**1 Products affected**

**3 Detailed description of change**

Engineering Documentation					PCN 4790/4795 - New contacts, material of cable guards		
owner	creation date	release date	released by	change order	rev	page	D10-096-327
huberth	09.12.2025	16.03.2026	gassmael		A	1 of 2

Current product appearance 4790	New product appearance 4790

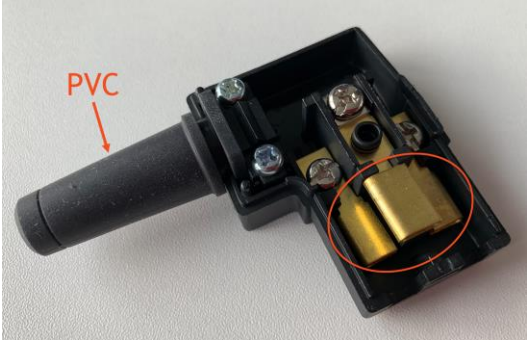
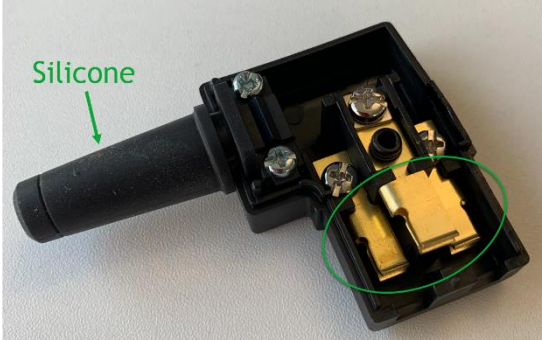
- Change of design for contacts L, N and PE.
- Change of material for cable guards from PVC to Silicone.
